Summit County Planning Commission (SCPC)
Thursday, March 31, 2022 - 3:00 p.m.
County of Summit, County Council Chambers
175 South Main Street, 7th Floor, Akron, Ohio
Meeting Agenda

Planning Commission
Preliminary Plan
Meadows of Wintergreen
Springfield Township

The Meadows of Wintergreen Phase 4 Preliminary Plan

The Meadows of Wintergreen Phase 4 Preliminary Plan
 Title Sheet
 Springfield Township
 Summit County, Ohio

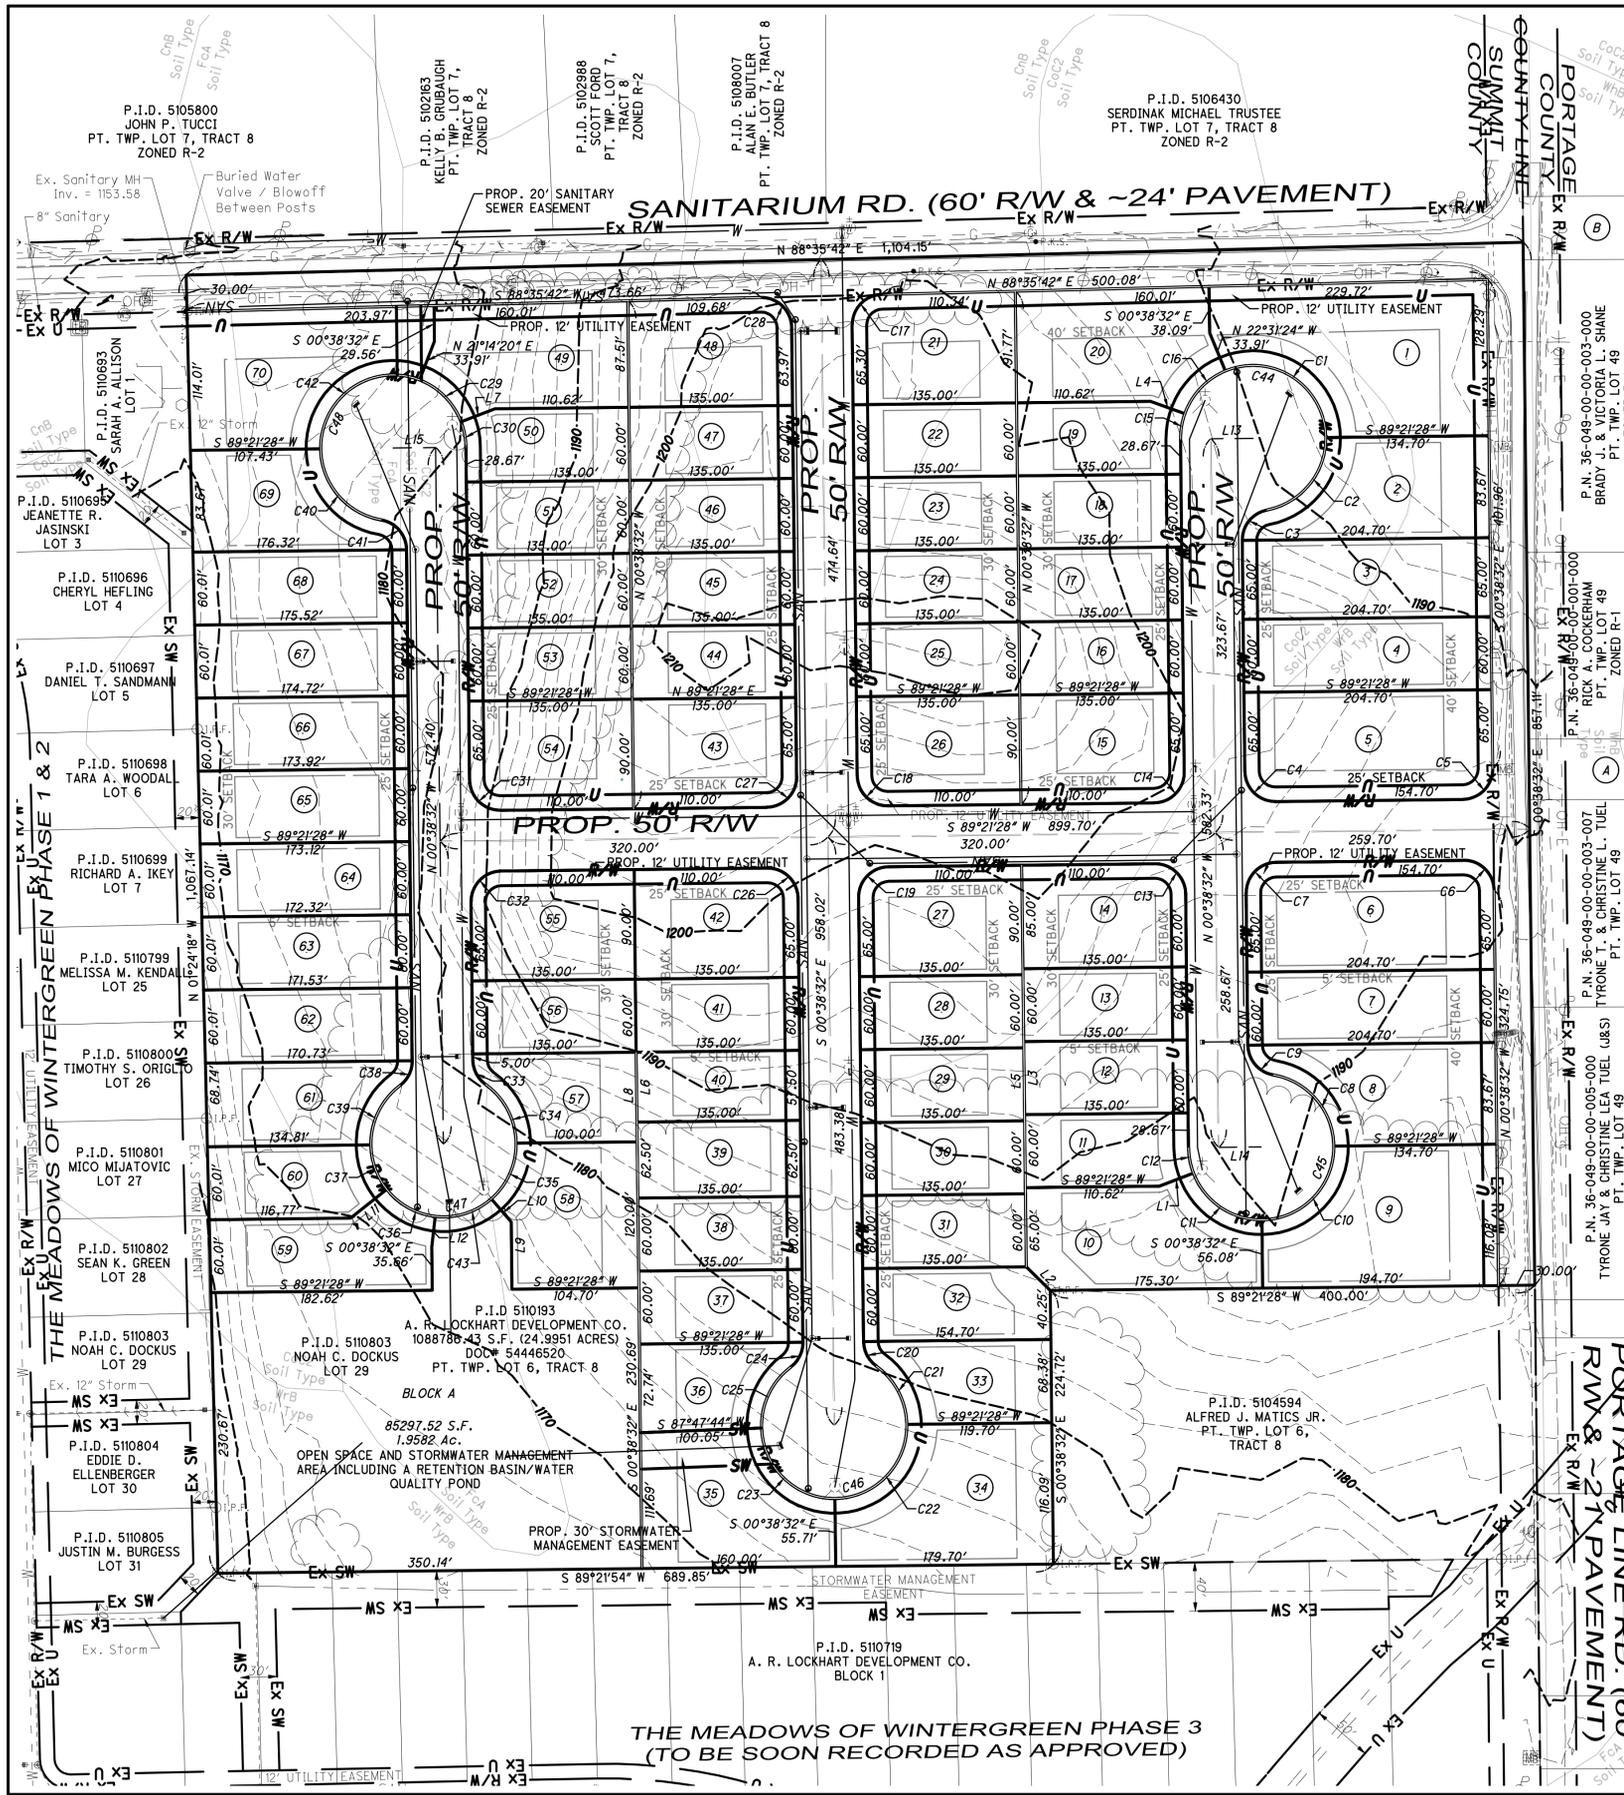
1. *All Stormwater Management for the site must follow the SCE Stormwater Drainage Manual, Current Edition (Revised 1/1/20). The proposed SWM Basin must have an adequate outlet.*

Wetlands: Potential wetlands have been identified on the 25 acre site. A wetland delineation will be required and a JD Letter from the Army Corps of Engineers. Any proposed impacts to wetlands must have the approval of the U.S. Army Corps of Engineers and the Ohio EPA in the form of permits from these agencies. A copy of any permits and any associated mitigation requirements must be forwarded to this office prior to plan approval.

Storm Water Pollution Prevention Plan and Post Construction Requirements: A Storm Water Pollution Prevention Plan (SWPPP) must be developed for this site and submitted to this office for approval. A post construction storm water quality practice must be designed per the OEPA NPDES Permit. All stormwater flow exiting this site must be treated by a structural post- construction water quality practice. The developer and consultant should refer to the Ohio EPA Phase II Construction General Permit, the Ohio Rainwater & Land Development Manual and Summit County Erosion/ Sediment Control, Post Construction Storm Water Quality - Chapter 941 for guidance. A Long-Term Maintenance Agreement between the County and Homeowner's Association will be required for the post construction practices.

1. Proposed roadways need names.
2. Subdivision Regulation 1108.07(f) “Roads intersecting another road from opposite sides shall be at least three hundred (300) feet apart, measured between centerlines. – there is a road length were this is not met. The road needs to be moved or a variance for this needs to be submitted to the Summit County Planning Commission.

Recommendation: It is Staff’s recommendation that the SCPC **Conditionally Approve** the Preliminary Plan, with the conditions of satisfying the comments of the Summit County Engineer’s Office, Summit Soil and Water Conservation District and Planning Staff.

Meadows of Wintergreen Phase 4 Preliminary Plan

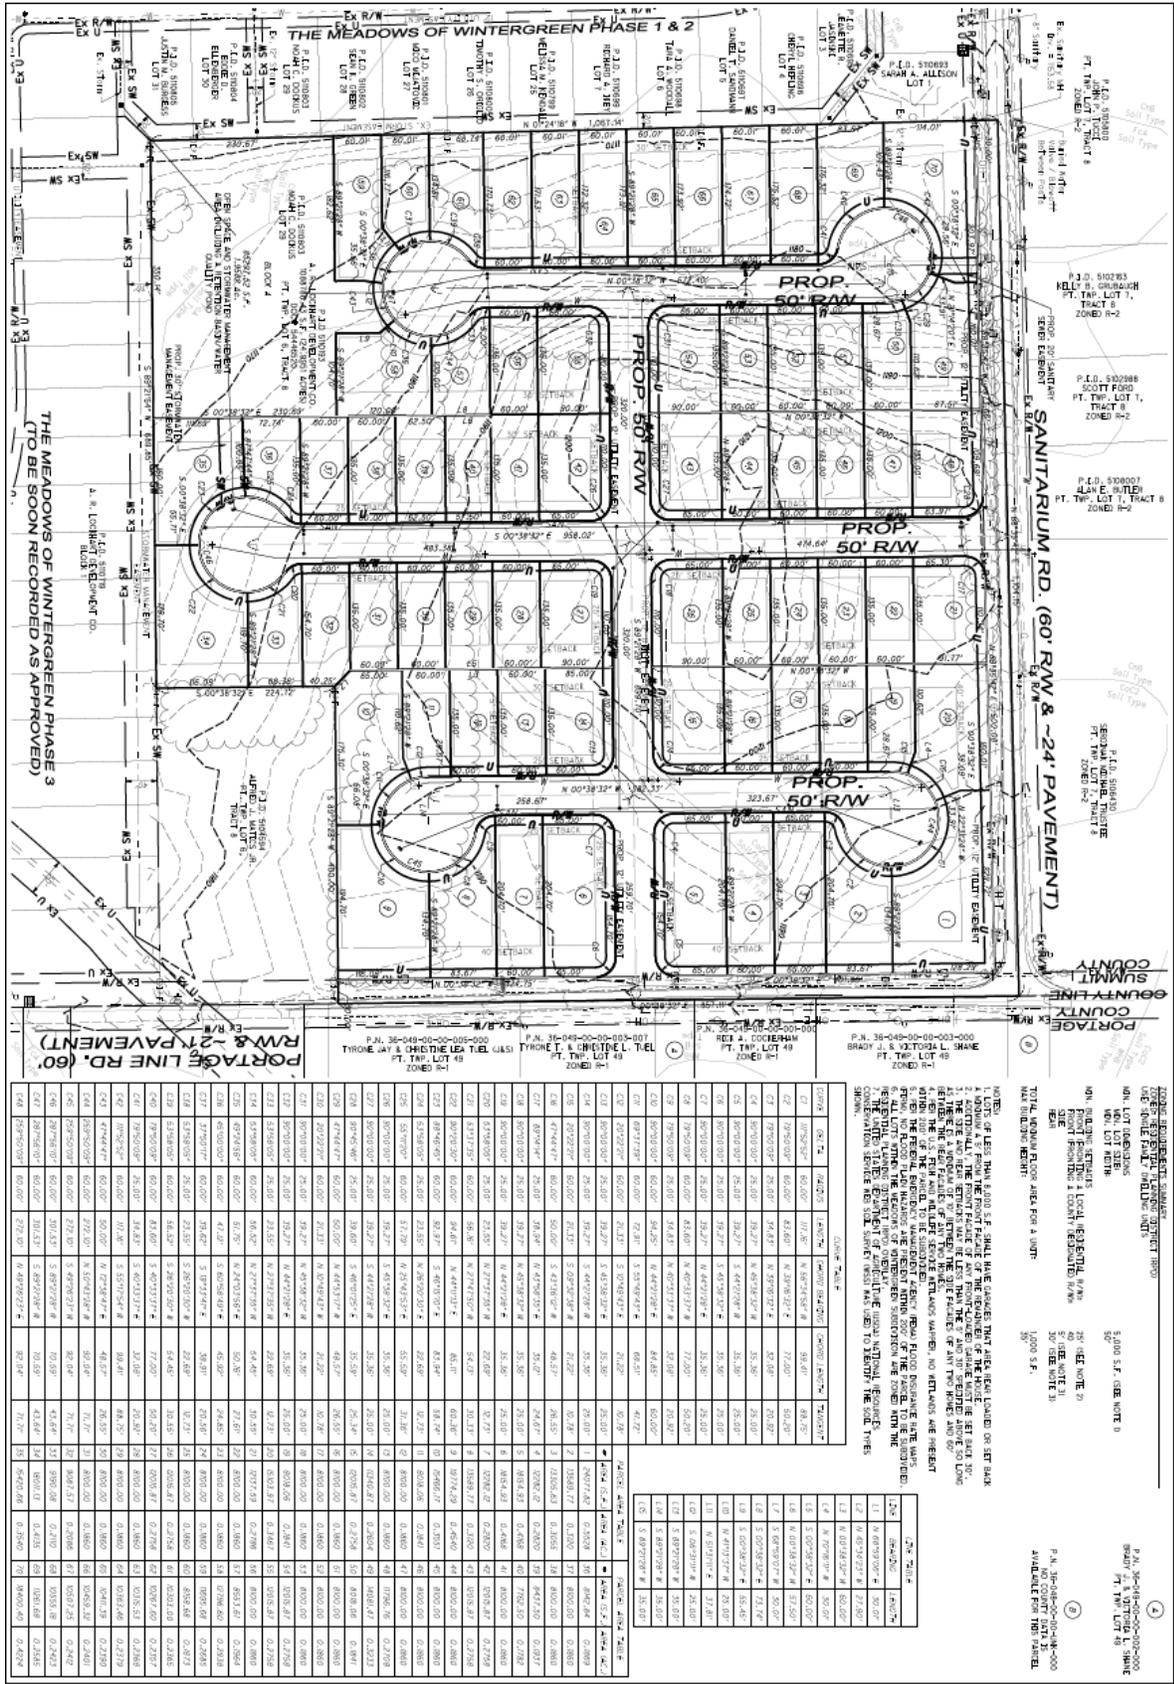
Manual, Current Edition (Revised 1/1/20). The proposed SWM Basin must have an adequate outlet.

10. *The Traffic Impact Questionnaire requires a Traffic Impact Assessment be completed for this project since the projected Daily Trips of 730 is within 500 - 749 trips on a typical weekday.*

must have the approval of the U.S. Army Corps of Engineers and the Ohio EPA in the form of permits from these agencies. A copy of any permits and any associated mitigation requirements must be forwarded to this office prior to plan approval.

Storm Water Pollution Prevention Plan and Post Construction Requirements: A Storm Water Pollution Prevention Plan (SWPPP) must be developed for this site and submitted to this office for approval. A post construction storm water quality practice must be designed per the OEPA NPDES Permit. All stormwater flow exiting this site must be treated by a structural post- construction water quality practice. The developer and consultant should refer to the Ohio EPA Phase II Construction General Permit, the Ohio Rainwater & Land Development Manual and Summit County Erosion/ Sediment Control, Post Construction Storm Water Quality - Chapter 941 for guidance. A Long-Term Maintenance Agreement between the County and Homeowner's Association will be required for the post construction practices.

1. Proposed roadways need names.
2. Subdivision Regulation 1108.07(f) "Roads intersecting another road from opposite sides shall be at least three hundred (300) feet apart, measured between centerlines. – there is a road length were this is not met. The road needs to be moved or a variance for this needs to be submitted to the Summit County Planning Commission.

Recommendation: It is Staff's recommendation that the SCPC **Conditionally Approve** the Preliminary Plan, with the conditions of satisfying the comments of the Summit County Engineer's Office, Summit Soil and Water Conservation District and Planning Staff.

SWCD: Sasha Mikheidze, 3/8/2022:

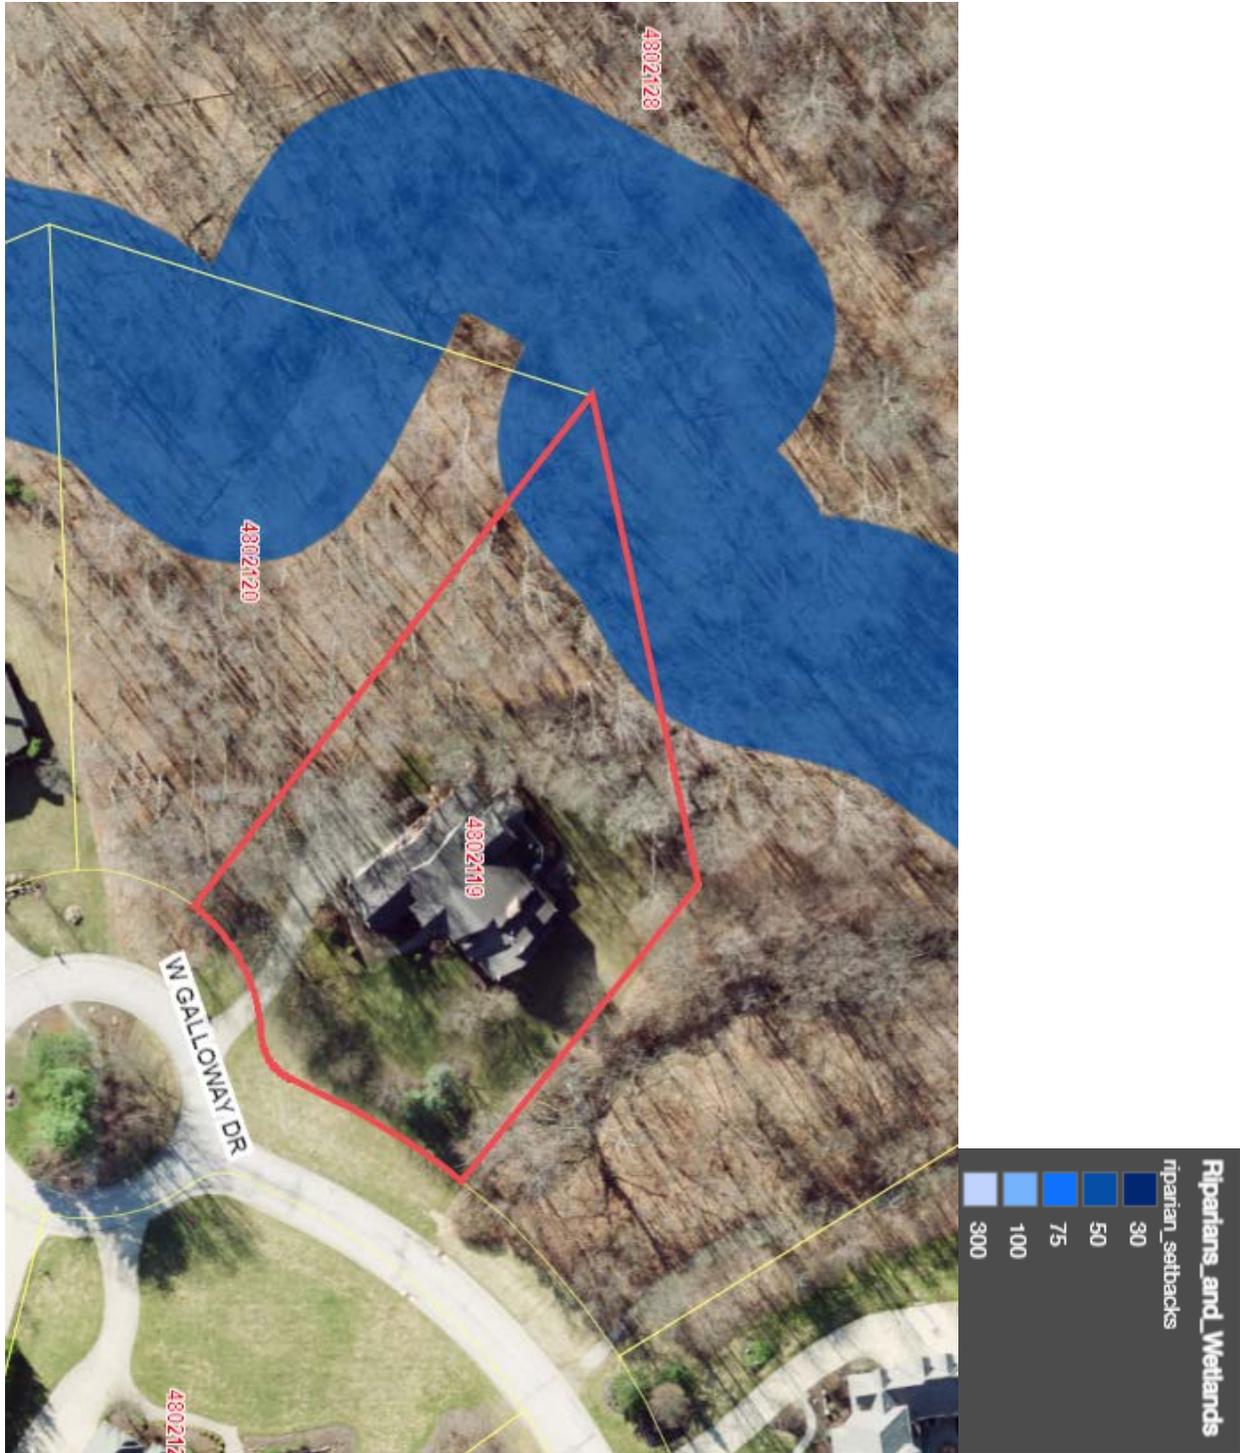
Summit Soil and Water Conservation District conducted a riparian setback assessment for the site and found a base setback of 50' plus an additional 100' due to severe slopes. As a result, SSWCD does not support the request for a variance for the purposes of installing a pool. Based on the riparian regulations, disturbing the setback for the purposes of installing a pool is not an approved activity within the setback.
